SUBJECT: Responds to RAI re proposed amend concerning thermal power update.

Re: Turkey Point Units 3 and 4  
Docket Nos. 50-250 and 50-251  
Request for Additional Information (RAI)  
Proposed License Amendments  
Thermal Power Uprate

Response to NRC Request  
for Additional Information  
Related to Thermal Power Upgrading  
at Turkey Point Units 3 and 4

L-96-117

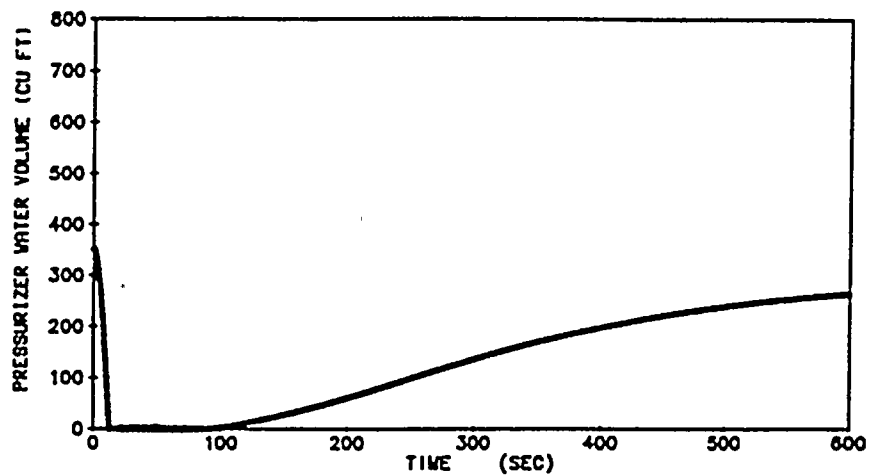
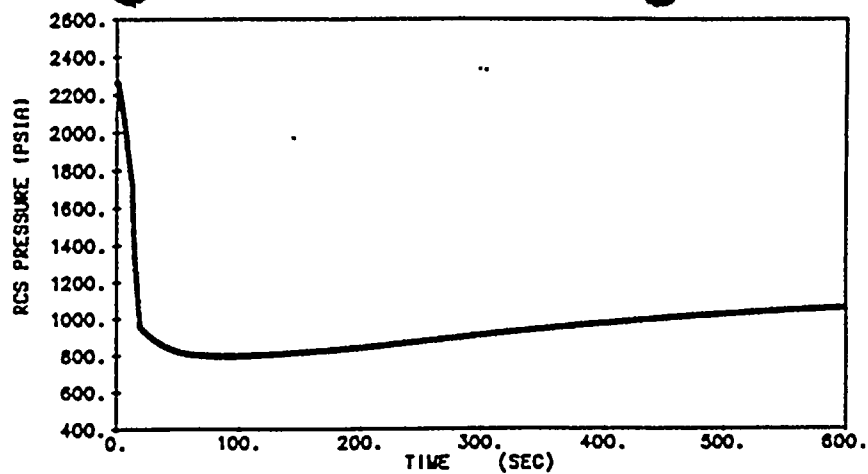
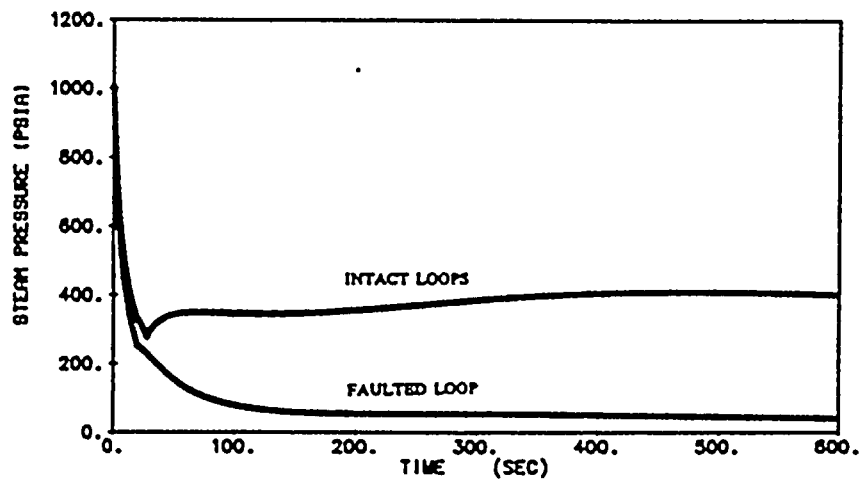
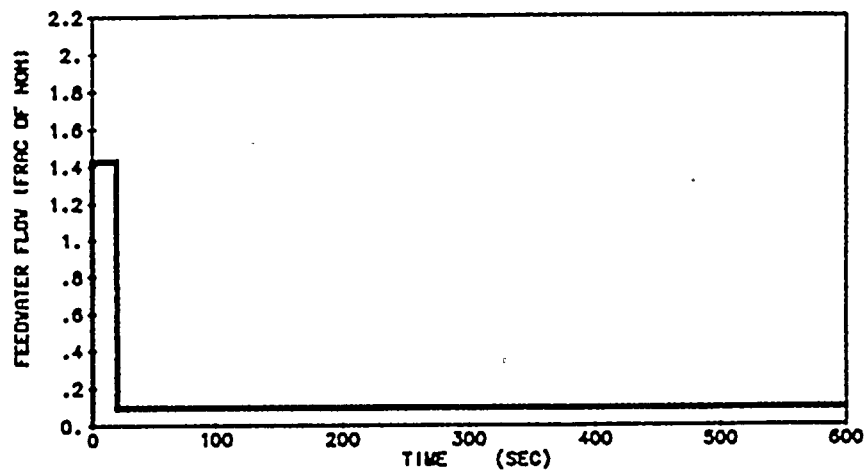
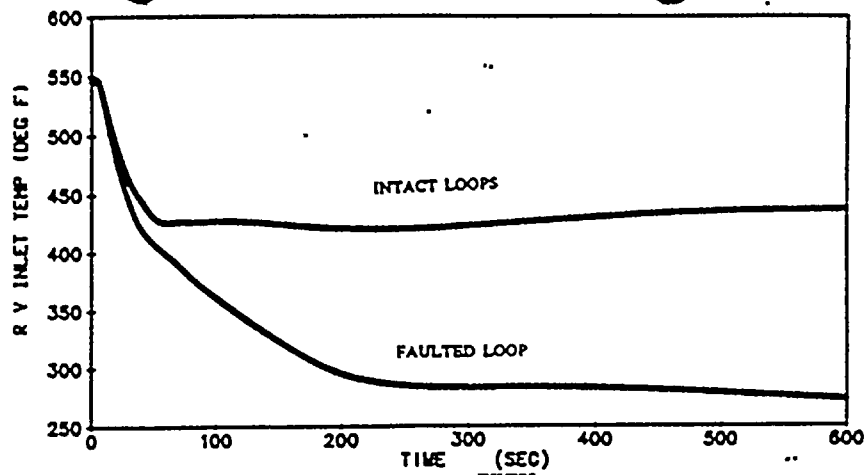
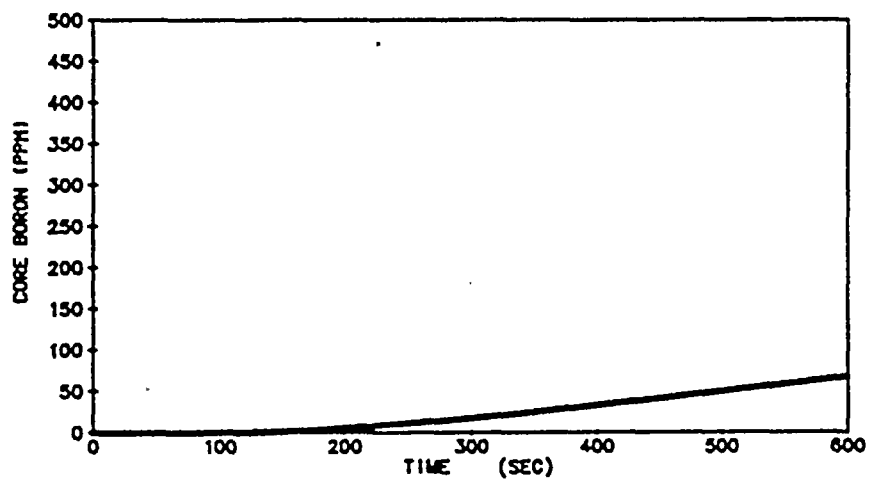
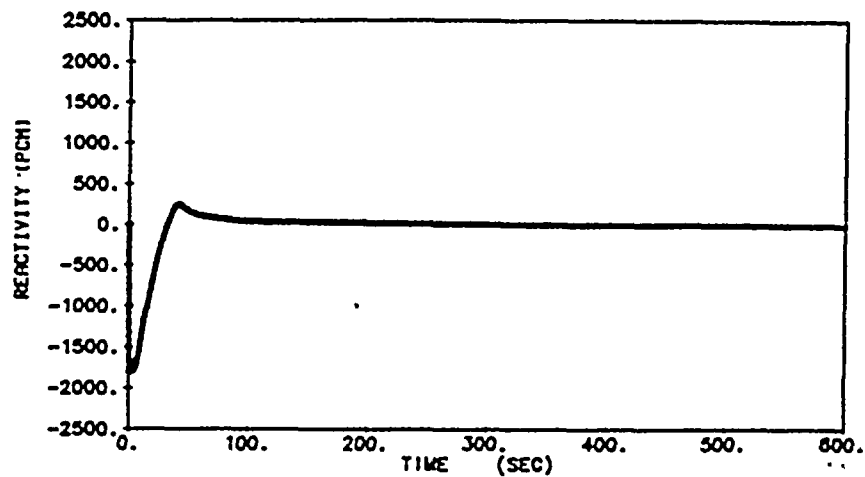
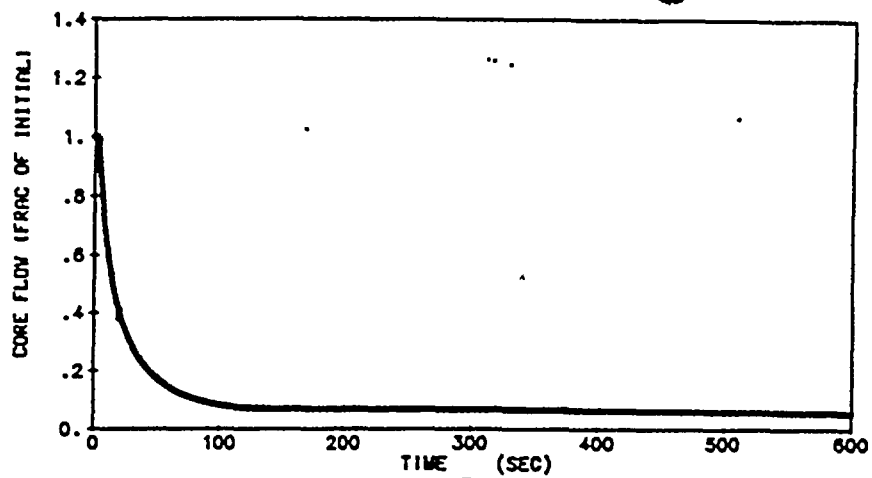
5. "Provide major transient curves for the reanalysis of the postulated main steam line break."

The Main Steam Line Break (MSLB) core response analysis is performed at Hot Zero Power (HZP) conditions, which did not change for the power uprating, and the HZP stuck rod coefficients remained applicable for uprated conditions since these are calculated at HZP and

parameters affecting these coefficients (mainly the moderator density coefficient) have not changed for the power uprating conditions. Therefore, the analysis performed under the RTDP project is not affected by the uprating and the DNBR design basis continues to be met. The curves associated with the proposed UFSAR write-up for the MSLB event are attached.
